STATE OF MARYLAND WELL COMPLETION REPORT

MEMORANDUM

RE: Hobbs Property
Orion Drive

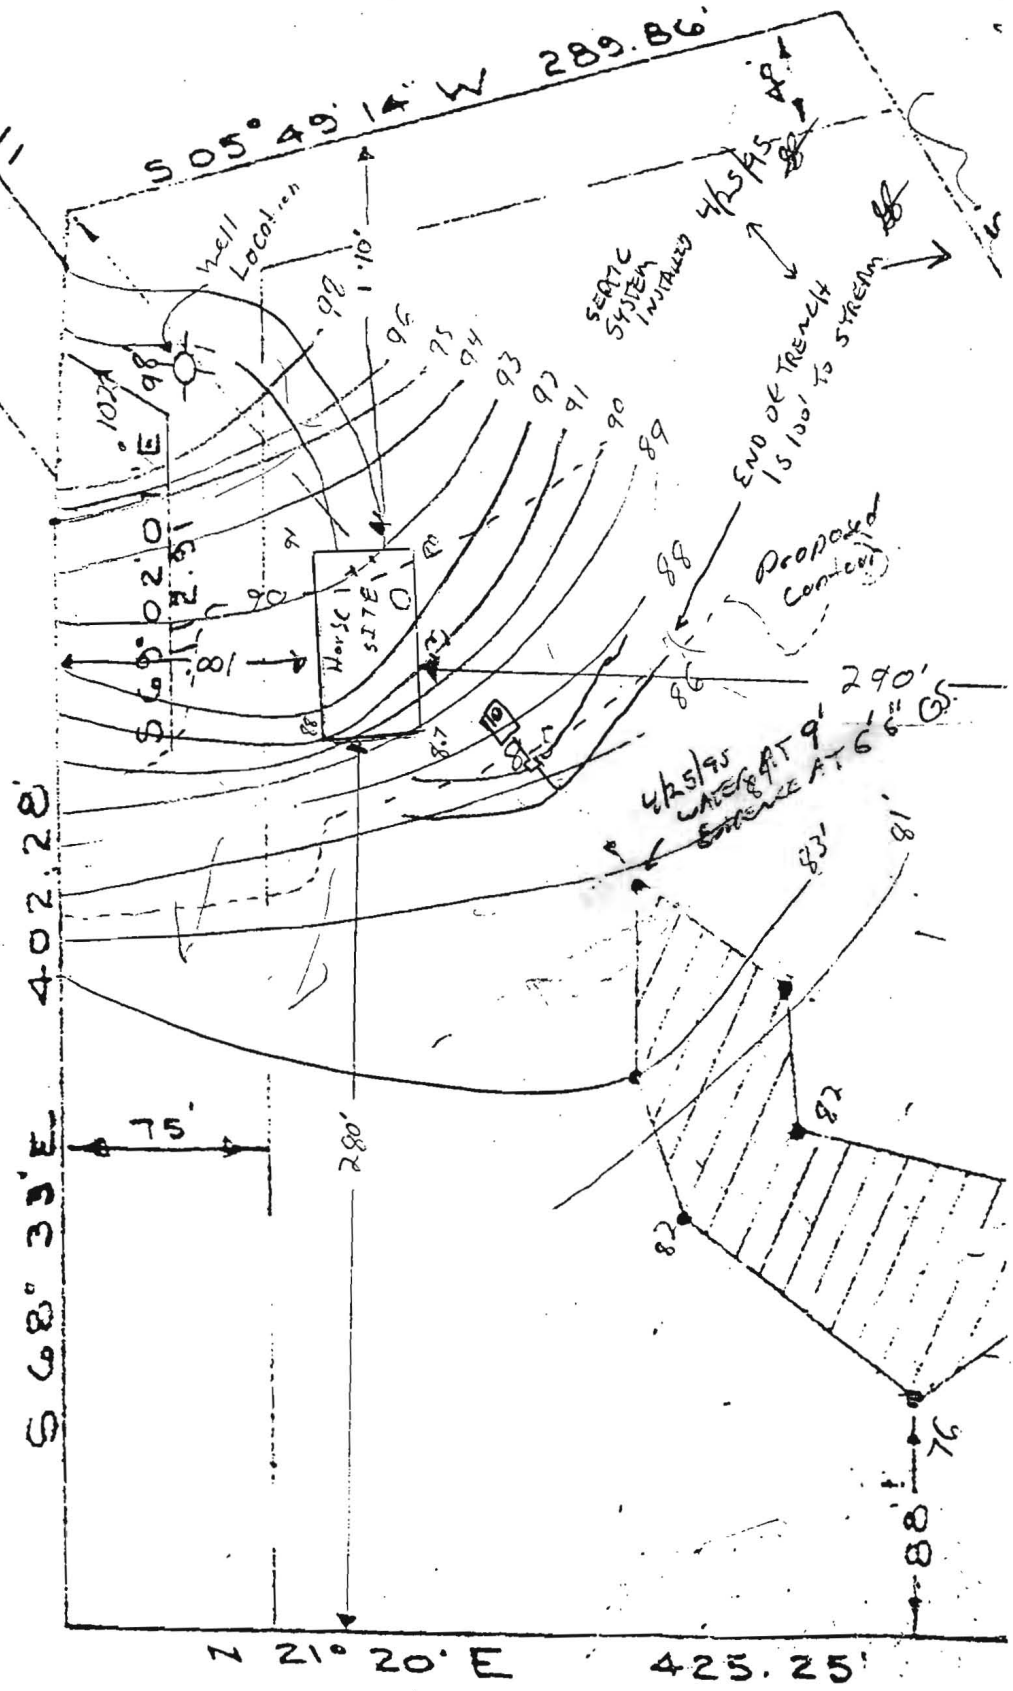
SYSTEM INSTALLED
& APPROVED 4/25/95,
DESPITE SOME SITE COMPLICATIONS
AFFECTED INITIAL LOCATION
& FUTURE REPAIR OPTIONS.

Percolates have been found located. Elevation 3/21/80
 APPROVED: for Private Water & Sewerage System
 Howard County Health Department.
